Dear Dr. Christa Kelleher,

## Response to Reviewer 1

## Response to Reviewer 2

Figure 2: Annual simulated evapotranspiration (ET) rates at wetland-FEN site in blue lines compared with observed ET at FEN flux tower represented in red lines. Years 2011 and 2012 have missing observations.

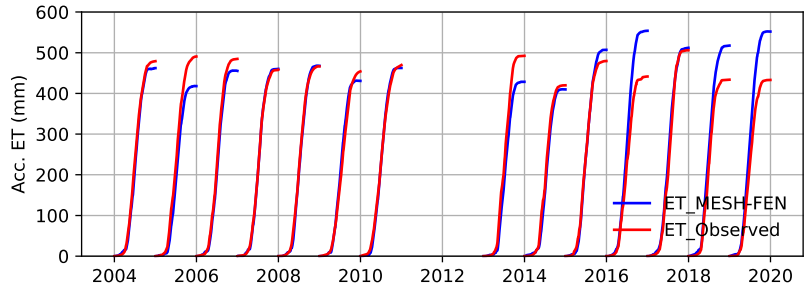
This paper explores how to adequately represent wetlands in land surface models, with a case study in White Gull Creek, Saskatchewan. The authors find that existing parameterizations which ignore groundwater and upland influences to be inadequate and make some recommendations for how to improve the representation of wetlands in LSMs. The authors explore four different model representations, from fully uncoupled to fully coupled. The main conclusion of the paper is that explicit groundwater interactions must be accounted for to adequately represent wetlands in LSMs, with chained and fully coupled modeling approaches working well under different circumstances. Overall I think the paper was interesting, and straightforward to understand. However, I think this paper is only able to make a conceptual argument for this case, rather a quantitative one. The only comparison to observations comes from the comparison of the groundwater level in the upland site, which tests the ability of the model to represent the upland, but not the wetland. Of course, I am sympathetic to the fact that observations of discharge from the fen don't exist, making this a large challenge.

However, I think the paper would be stronger if it could make a quantitative argument for the need for coupled models in representing the wetlands component, rather than a conceptual one. I think some additional analysis looking at either some downstream discharge could be useful for making this point, if such a stream gauge exists. I think correlating such a streamflow with the daily outflow into the river from your model setups could yield an interesting result. Similarly, correlating the  $E_f$  from your fen model with latent heat from the FEN tower vs the OJP tower could make a good case for including the coupling between the wetland and upland. Because of these recommendations for additional analysis, I am recommending major revisions.

We have compared the simulated ET from the FEN and OJP towers with those produced by our model (Figure 1 and 2). The simulated ET at Fen site (Figure 1) is overestimated in some years, compared with the measured fluxes. This is because of limitations with how MESH simulates evapotranspiration from wetlands (which are not explicitly represented in MESH), and the model always calculates evapotranspiration at the potential evapotranspiration rate. The simulated ET rates at OJP (Figure 2) have a systematic overestimation, with larger errors after 2012. This was explored in Nazarbakhsh et al., 2020, who found that the errors are happening during the melt period – a problem that is yet to be resolved in MESH.
